Intel[®] Pentium[®] III Processor Specification Update

Release Date: May 2003

Document Number: 244453-048

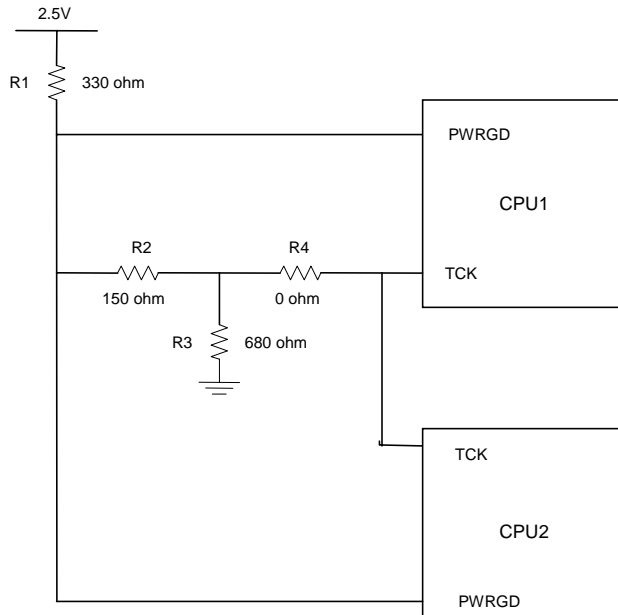
Problem: The internal control register bit responsible for operation of the Thermtrip circuit functionality may power up in a non-initialized state. As a result, THERMTRIP# may be incorrectly asserted during de-assertion of RESET# at nominal operating temperatures. When THERMTRIP# is asserted as a result of this erratum, the processor may shut down internally and stop execution but in few cases continue to execute.

Implication: This issue can lead to intermittent system power-on boot failures. The occurrence and repeatability of failures is system dependent, however all systems and processors are susceptible to failure. In addition, the processor may fail to stop execution during the event of a valid THERMTRIP# assertion resulting in the potential for permanent processor damage.

Workaround: To prevent the risk of power-on boot failures or catastrophic thermal failures, a platform workaround is required. The system must provide a rising edge on the TCK signal during the power-on sequence that meets all of the following requirements:

- Rising edge occurs after Vcc_core is valid and stable
- Rising edge occurs before or at the de-assertion of RESET#
- Rising edge occurs after all Vref input signals are at valid voltage levels
- TCK input meets the Vih min and max spec as mentioned in EMTS
